OVER THE SOLDERING IRON

RCA VICTOR

SERVICE DIVISION - RCA MANUFACTURING COMPANY, INC. - CAMDEN, N.J., DECEMBER 1, 1938

MODIFIED ELECTRIC TUNING DRIVE SYSTEM

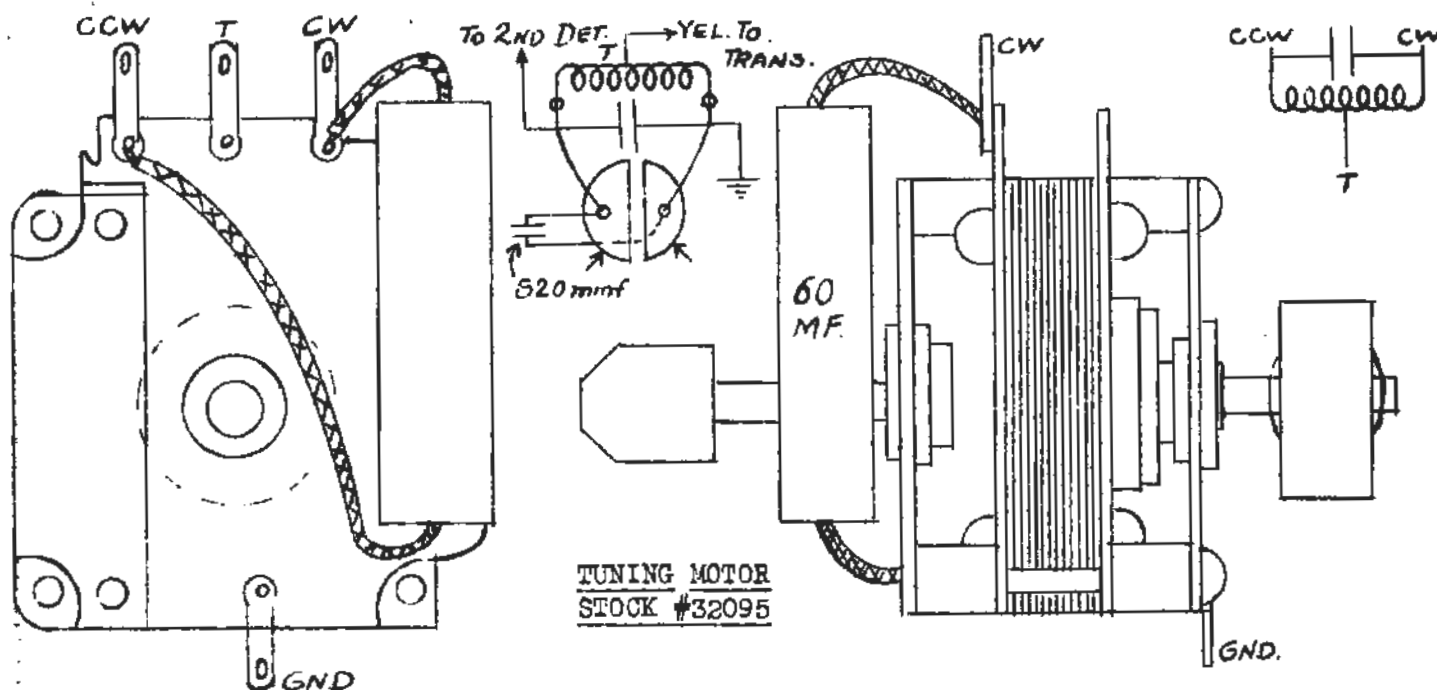
Some 1938-39 electric tuning models incorporate a drive motor corresponding to the above diagram. This motor employs a friction clutch, its flywheel requires no adjustment, and starting is accomplished by means of a capacitive phase shifting circuit. Replacement stock numbers and models involved are as follows:-

Stock #31235 motor having mechanical clutch, is replaceable for service purposes where desired by the modified motor #32095 (a) if the revised bracket (b) and drive (c) are used as specified above. The #31235 motor will be continued as a replacement part.

NOTE #3 - An 820 mmf. must be added across the selector disc circuit.

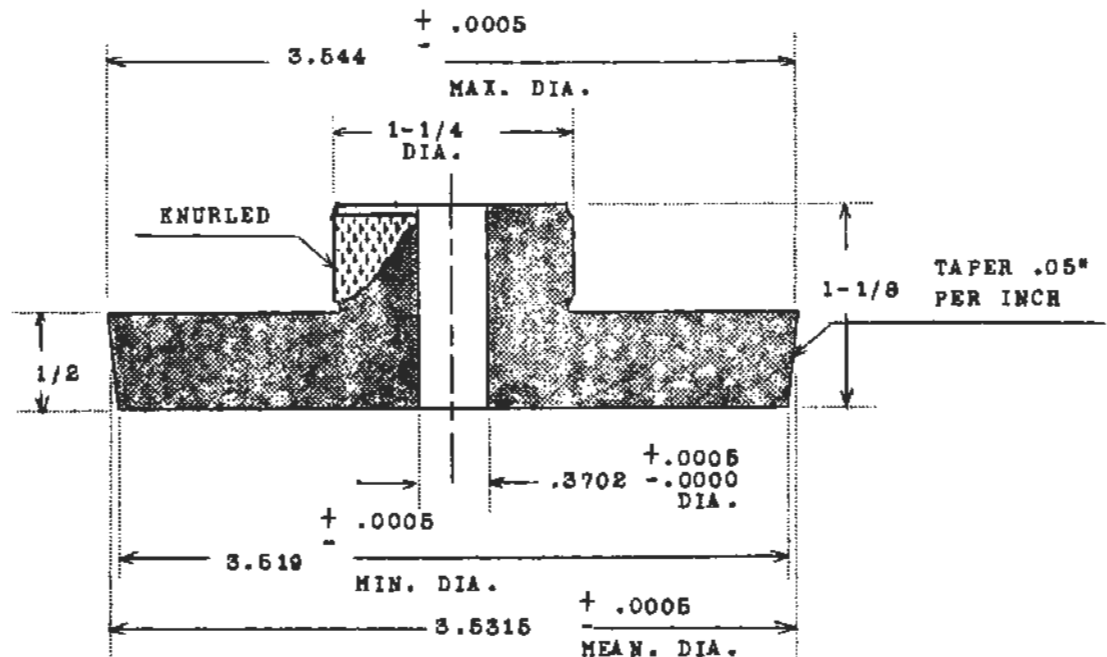
- (1) Jamming of 10 inch records is generally related to adjustment of record separator knives. More satisfactory operation is obtainable by using a spacing of .058 inches for 10 inch records in lieu of the originally specified .055 inches. If adjustment does not give foolproof operation, replace the separator knives. The present type of separator - Stock #31126 - has an edge corresponding to the right diagram below -
